## CITY of NOVI CITY COUNCIL

Agenda Item 4  
January 10, 2011

**SUBJECT:** Consideration of the request of Novi Town Center Investors, LLC for Preliminary Site Plan approval. The subject property is located in Section 14 near the northwest corner of Eleven Mile Road and Town Center Drive, in the TC, Town Center District. The subject property is approximately 35.7 acres and the applicant is proposing to construct an approximately 17,500 square foot retail building to connect the existing Novi Town Center to the proposed Walmart store.

# Walmart SP10-42A and Novi Town Center Building X.1 SP10-41A

**A 1:1** CAD (DWG P, AEC2, PRELIMINARY SITE PLAN SUBMITTAL) 2-11-20

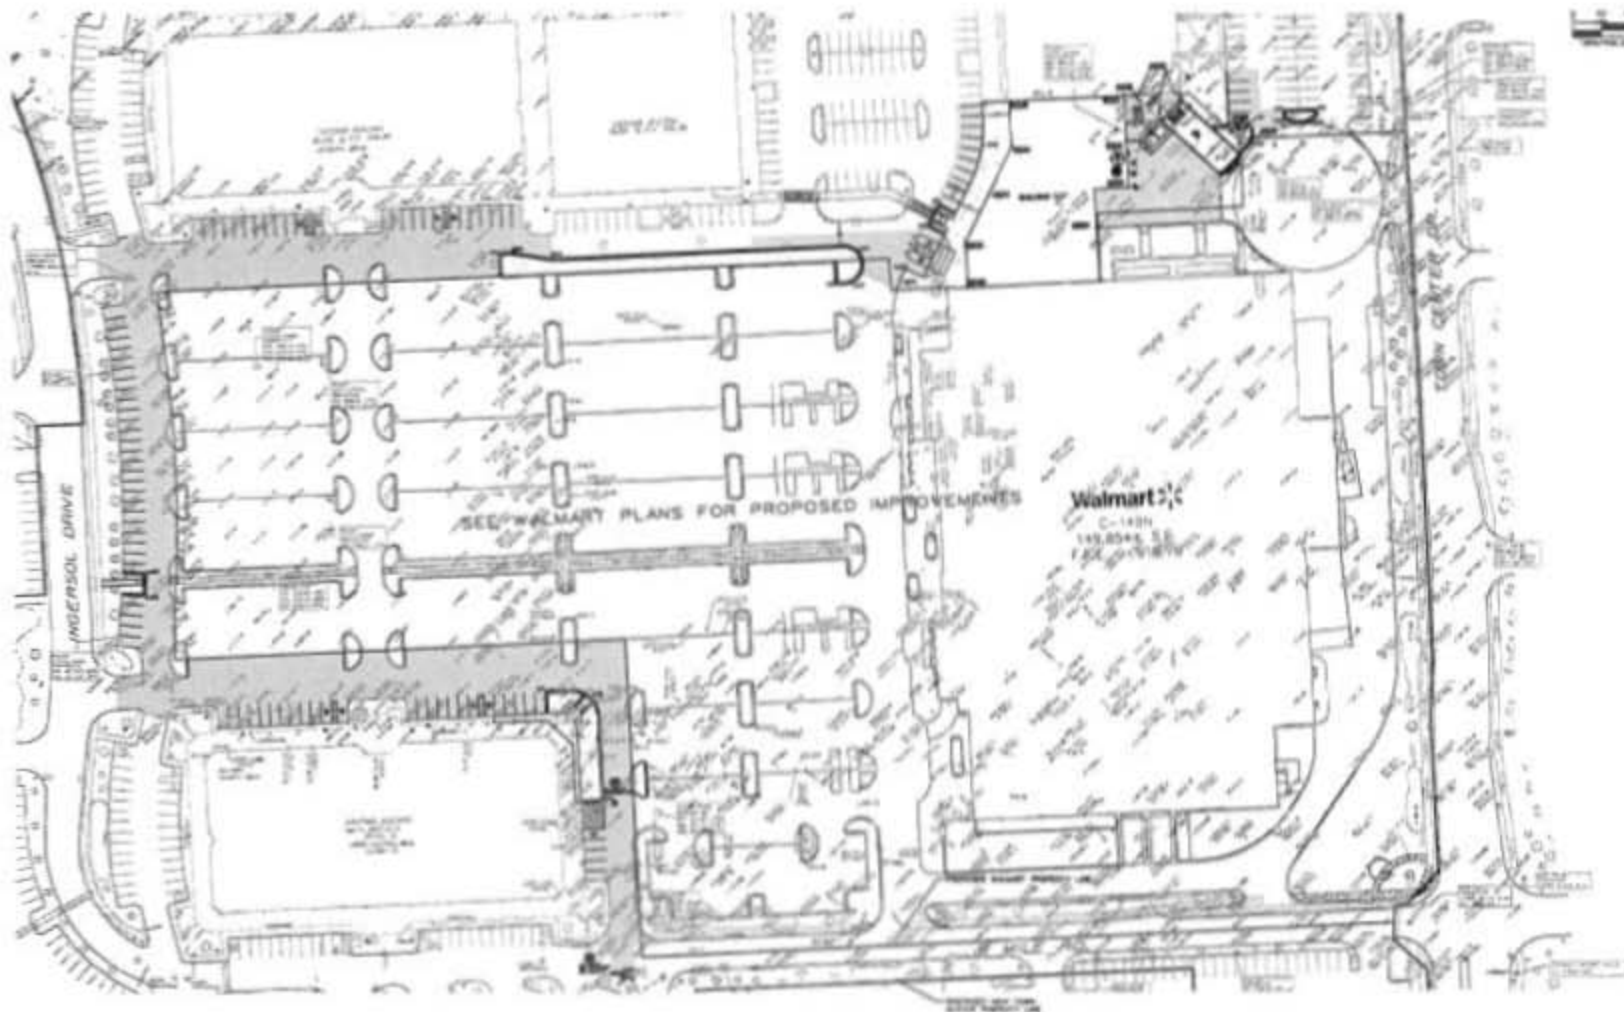
1. Building Setback: Due to the proposed parcel split, the interior side (north) yard building setback and exterior side (east) yard are proposed to be 0'. (15' and 50' are required.) **The applicant can seek a setback reduction from the City Council.** In the TC District, the City Council can reduce building setbacks if the conditions listed in Section 1602.4 are met. Please refer to the planning review chart for specific conditions.
2. Parking Setbacks: Due to the proposed parcel split, the interior side (north) yard parking setback is proposed to be 0' and the exterior side (east) yard parking setback is proposed to be 10'. (20' is required.) **The applicant should seek variances from the Zoning Board of Appeals.**

3. Parking Spaces: In order for parking requirements to be fulfilled for the entire site, parking must be shared between the Novi Town Center and the proposed Walmart. **The applicant should include a note on the plans stating parking will be shared between these two sites.**

9. Site Plan: **Please provide a sheet titled "site plan" showing the proposed exterior changes using an engineer's scale.**
10. Parcel Split: At this time, no property combination or split has been submitted and the Planning Division has not received a request for condominium approval that would affect the subject property. The applicant must create this parcel prior to Stamping Set approval. Plans will not be stamped until the parcel is created.

1. A note will be added to Site Plan sheet A 1.1 stating that a City Council waiver will be requested to reduce the South, interior building side yard from the 15' required per ordinance to 0', and to reduce the East, exterior building side yard from the 50' required per ordinance to 0'.

2. A note will be added to Site Plan sheet A 1.1 stating that a Z.B.A. variance will be requested to reduce the South, interior parking side yard from the 20' required per ordinance to 0' and to reduce the East, exterior parking side yard from the 20' required per ordinance to 0'.

3. A note will be added to Site Plan sheet A 1.1 stating that a shared parking agreement will exist between the Walmart parcel and the Novi Town Center parcel.

9. The name of sheet A 1.1 will be changed to Site Plan in lieu of Master Plan. A dash line will also be added to indicate the buildings being demolished.
